Staff Report
City of Richmond, Virginia

Commission of Architectural Review

COA-098250-2021	Final Review	Meeting Date: 9/28/2021
Applicant/Petitioner	Justin Drumwright	
Project Description	Rehabilitation of a 2-story, detached, single-family home; construct a rear, 2 nd story addition	
Project Location		
Address: 810 Jessamine St.		
Historic District: Union Hill		
High-Level Details: <ul style="list-style-type: none"> The applicant proposes to construct a rear, 2nd story addition to a ca. 1870 Greek Revival house. The original front porch columns were replaced prior to the Union Hill City Old and Historic District Designation. Staff notes that the work has already been completed. 		
Staff Recommendation	Approval, with Conditions	
Staff Contact	Alex Dandridge, alex.dandridge@rva.gov , (804) 646-6569	
Previous Reviews	None.	
Conditions for Approval	<ul style="list-style-type: none"> Staff recommends that the rear second story addition be differentiated from the existing house using a different material or applying an exterior feature that gives reference to the historic roofline. Staff recommends that a material in-keeping with the guidelines be utilized, and that it be smooth and w

Figure 5. Existing rear elevation, showing the new addition.

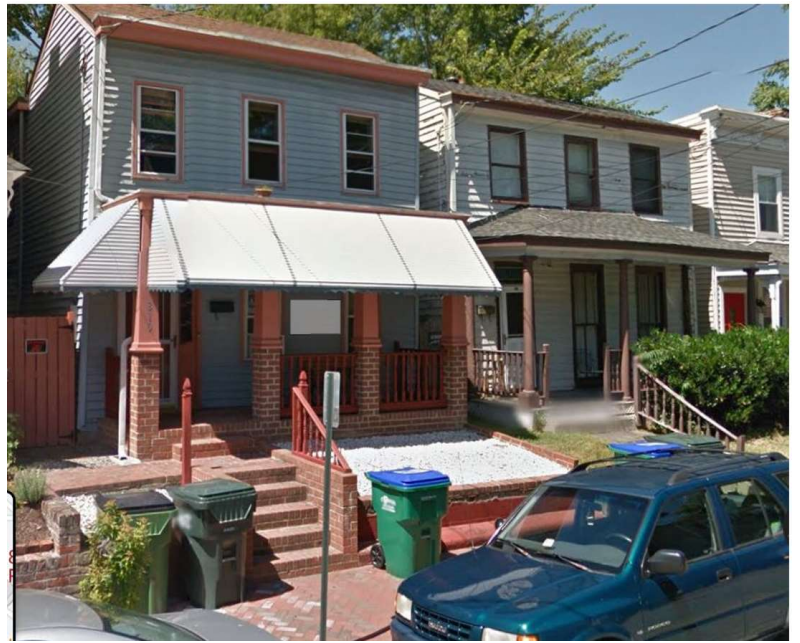
Guideline Reference	Reference Text	Analysis
Siting #1, pg. 46	<i>Additions should be subordinate in size to their main buildings and as inconspicuous as possible. Locating additions at the rear or on the least visible side of a building is preferred.</i>	The proposed addition is subordinate in size to the main building and is located in the rear.
Materials, #1, p. 47	<i>Additions should not obscure or destroy original architectural elements.</i>	The new addition will align with the existing roof line of the main building, and the roofline of the rear one story projection will be eliminated. Staff notes that the new addition as constructed is not differentiated from the main structure, being the same material and aligning with existing wall faces, and matching the roofline. <u>Staff recommends that the rear second story addition be differentiated from the existing house using a different material or applying an exterior feature that gives reference to the historic roofline.</u>

Materials, #2, p. 47	<i>Materials used in new residential construction should be visually compatible with original materials used throughout the district.</i>	<p>The plans call for the installation of vinyl siding on the new rear addition. The applicant has confirmed that no original wooden siding was present on the residence, and that vinyl siding was removed, and new hardiplank siding was installed on the entirety of the residence, including the new addition. Staff notes that hardiplank siding is an approvable, substitute material when no salvageable, original siding is present. Staff also notes that the hardiplank siding installed appears to have a faux wood grain, which is not in-keeping with the guidelines.</p> <p>Staff notes that there are discrepancies between the project narrative and the architectural drawings, and <u>recommends that the architectural drawings be updated to show the correct proposed materials prior to applying for a building permit.</u></p>
